DETAILED COMMENTS BY THE ATTORNEY  
GENERAL ON THE

DRAFT ENVIRONMENTAL STATEMENT BY  
THE DIRECTORATE OF LICENSING  
UNITED STATES ATOMIC ENERGY COM-  
MISSION RELATED TO OPERATION OF  
INDIAN POINT NUCLEAR GENERATING  
PLANT UNIT NO. 3 FOR

CONSOLIDATED EDISON COMPANY OF NEW YORK, INC.

December 17, 1973

Figure 1

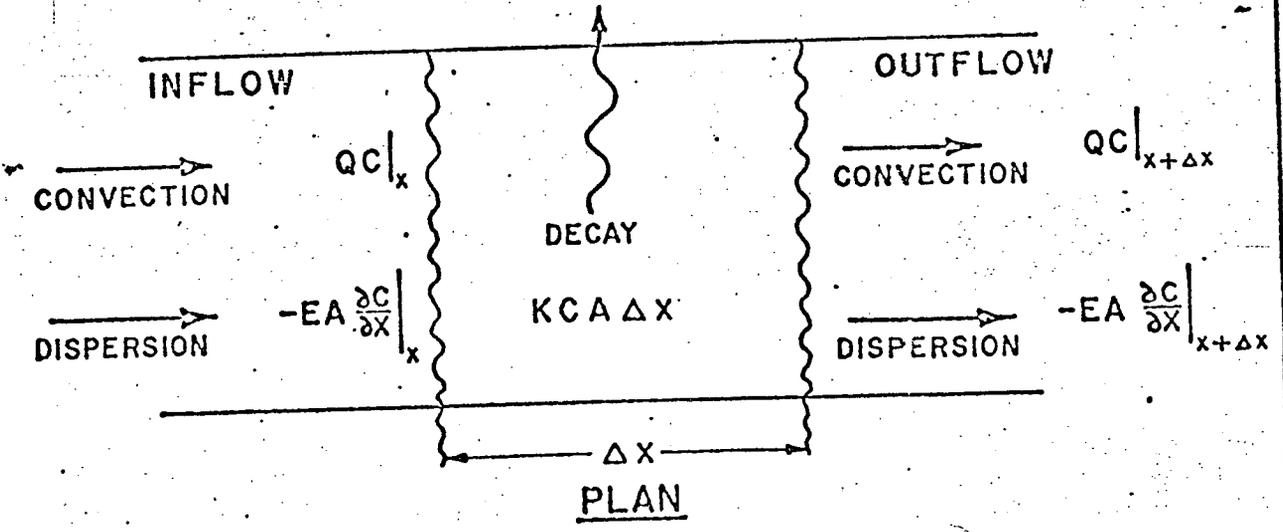
Without an accurate far-field model prediction of the intake water temperature, verification of the plant's compliance with State thermal criteria is impossible. There is no place on the Hudson where a true "ambient," relative to Indian Point, can be physically measured. All temperature measurements above and below Indian Point will be "polluted" with heat from other sources in the process of decay. (See Figure 1).
